Z-42
(2012)

ZONING CONCEPTUAL PLAN FOR:
BROOKS CHADWICK CAPITAL, LLC

PETITION NO: Z-42

ZONING COMMENTS:

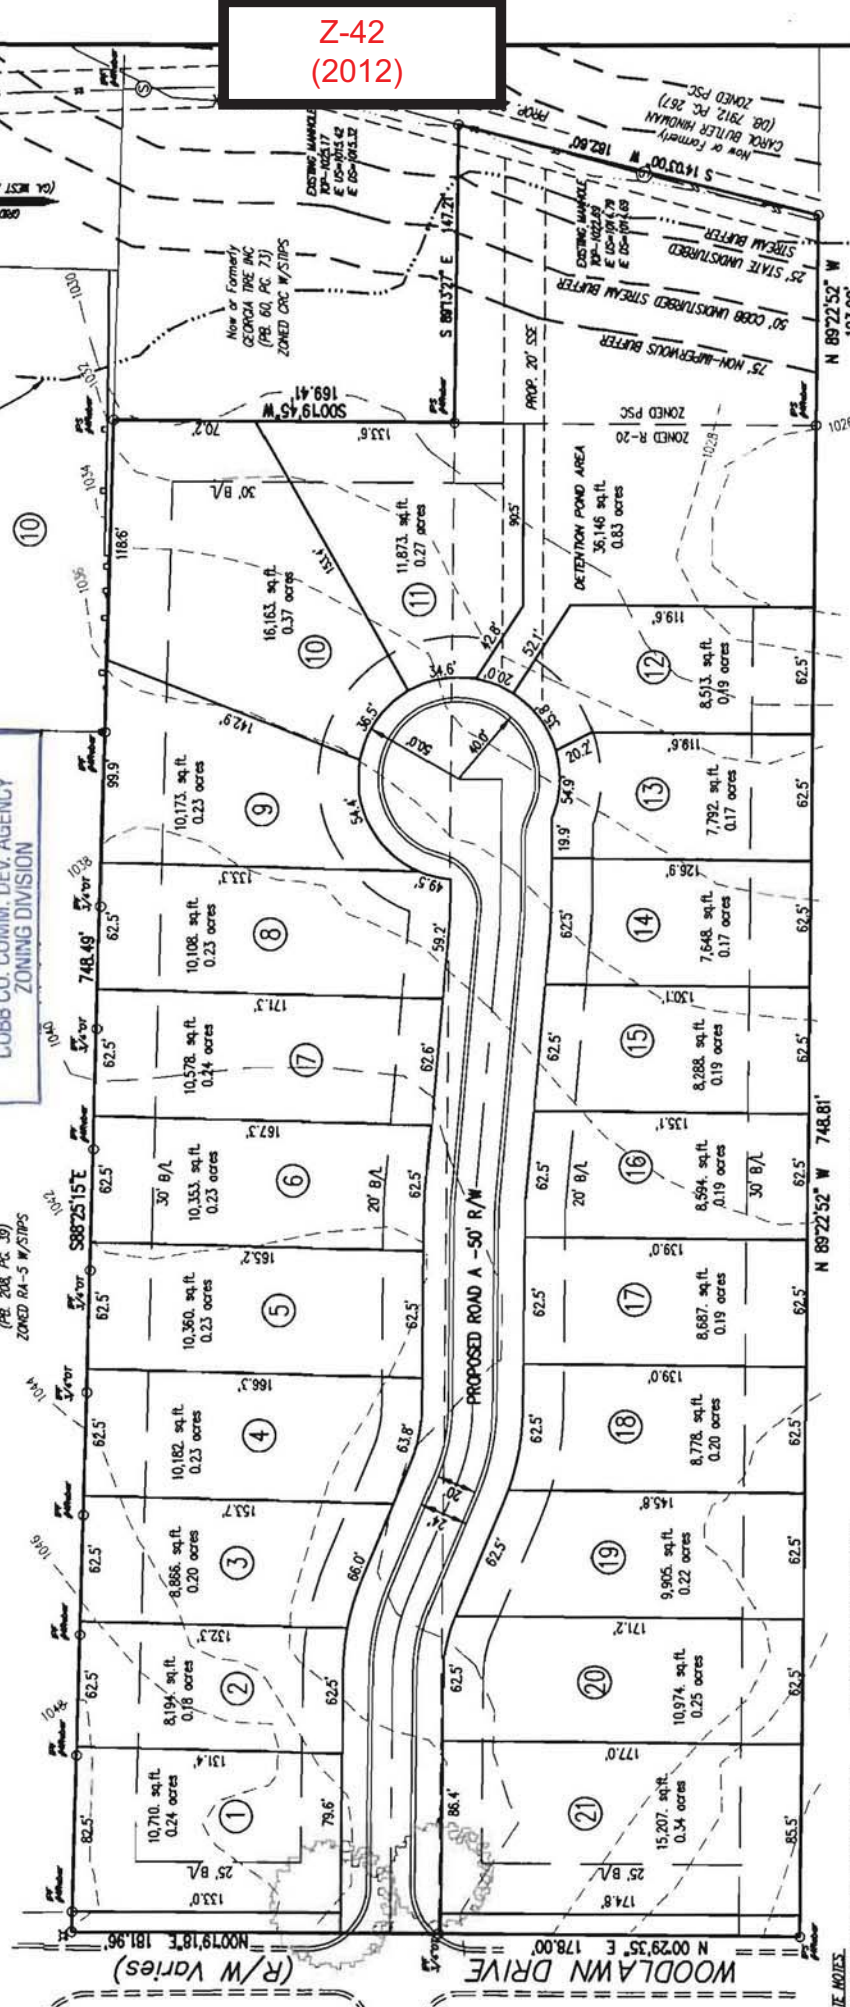
Applicant will need a contemporaneous variance to waive the exterior rear setbacks from the required 40 feet to 30 feet.

HYDRANT: Show fire hydrants arranged to have a hydrant available for the distribution of hose to any portion of any building on premises at distances not exceeding 500 feet (driving distance). Hydrants shall be at least 40 feet from the building (steamer connection facing street) (NFPA 24-7.2.3). Fire hydrants shall be spaced not more than 500 feet apart. Hydrants shall not be connected to water lines on the positive side (discharge side) of a fire pump. Minimum 8” supply lines to all hydrants.

Additional Comments: CCMWA must approve any road improvements that may impact their transmission line on E / side of Woodlawn Dr.

- FEMA Designated 100 year Floodplain Flood.
- Flood Damage Prevention Ordinance DESIGNATED FLOOD HAZARD.
- Project subject to the Cobb County Flood Damage Prevention Ordinance Requirements.
- Dam Breach zone from (upstream) (onsite) lake - need to keep residential buildings out of hazard.

- Provide comprehensive hydrology/stormwater controls to include development of out parcels.
- Submit all proposed site improvements to Plan Review.
- Any **spring activity** uncovered must be addressed by a qualified geotechnical engineer (PE).
- Structural fill _____ must be placed under the direction of a qualified registered Georgia geotechnical engineer (PE).
- Existing facility.
- Project must comply with the Water Quality requirements of the CWA-NPDES-NPS Permit and County Water Quality Ordinance.
- Water Quality/Quantity contributions of the existing lake/pond on site must be continued as baseline conditions into proposed project.
- Calculate and provide % impervious of project site.
- Revisit design; reduce pavement area to reduce runoff and pollution.

- No Stormwater controls shown _____
- Copy of survey is not current – Additional comments may be forthcoming when current site conditions are exposed.
- No site improvements showing on exhibit.

1. The majority of the site, 4.29 acres, drains to the east directly to Powers Creek which flows along the eastern boundary of the site. The remainder of the site drains to the southeast to the Woodlawn Drive right-of-way. The proposed plan will direct almost the entire site to the proposed stormwater management facility located at the easternmost portion of the site adjacent to Powers Creek.
2. A 20-foot drainage easement will be required along the rear of lots 10-20 to ensure that all site runoff will be directed to the proposed detention pond.

Woodlawn Drive is classified as a minor collector and according to the available information the existing right-of-way does not meet the minimum requirements for this classification.

Recommend applicant consider entering into a development agreement pursuant of O.C.G.A. 36-71-13 for dedication of the following system improvements to mitigate traffic concerns: a) donation of right-of-way on the east side of Woodlawn Drive, a minimum of 30' from the roadway centerline.

Recommend curb, gutter, and sidewalk along Woodlawn Drive frontage.

Recommend curb and gutter along both sides and sidewalk along one side of proposed development roadway.

Recommend a deceleration lane on Woodlawn Drive for the entrance.

Recommend applicant verify that minimum intersection sight distance is available and if it is not, implement remedial measures, subject to the Department's approval, to achieve the minimum requirement of 390 feet.
